City of **HOBART**

APPLICATION UNDER HOBART INTERIM PLANNING SCHEME 2015

Type of Report: Committee
Council: 6 August 2018
Expiry Date: 13 August 2018
Application No: PLN-18-103
Address: 35 DERWENTWATER AVENUE , SANDY BAY
Applicant: Dean Kelly (M2architecture)
25 Arthur Street (PO Box 114)
DAVID MENZIES
PO BOX 114
NORTH HOBART 7000
DAVID MENZIES
PO BOX 114
NORTH HOBART 7000
Proposal: Subdivision (Boundary Adjustment) and Multiple Dwellings
Representations: Seven (7)
Performance criteria: General Residential Zone Development Standards, Parking and Access Code, Stormwater Management Code, Historic Heritage Code, and Inundation Prone Areas Code

Figure 2: perspective image of the proposed development and the prescribed building envelope (indicated by gray shading).

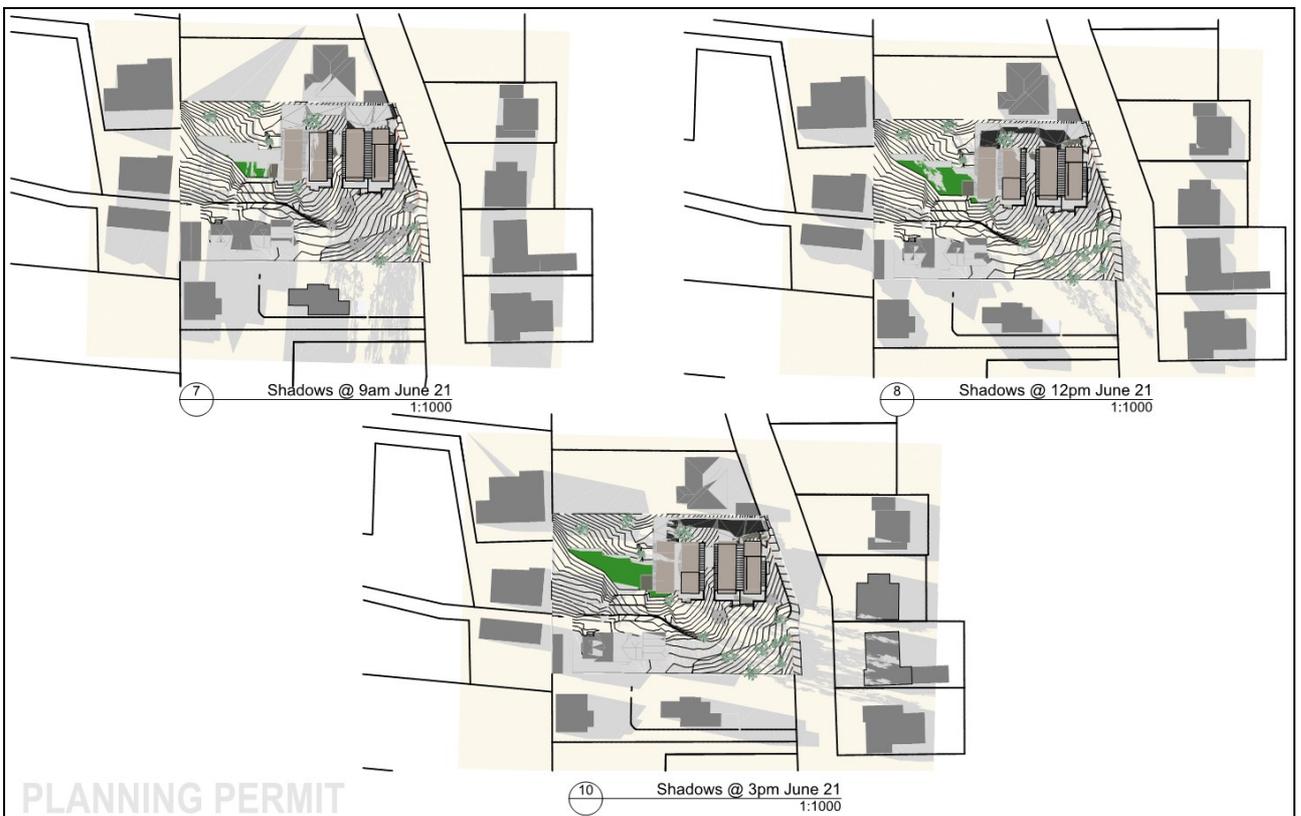
- 6.8.5 As shown on the below shadow diagrams, the proposed development would not cause a reduction in sunlight to a habitable room or overshadow private open space on an adjoining lot. The below diagrams show that any shadow cast by the proposed development would be contained within the site. The site is not adjacent to a vacant lot.
- 6.8.6 The proposed development would be visible from adjoining lots, however, it is not considered likely to have an unreasonable visual impact. The development would present as two storey when viewed from the adjoining lot to the south-west. The dwelling on this lot is above the level of the site
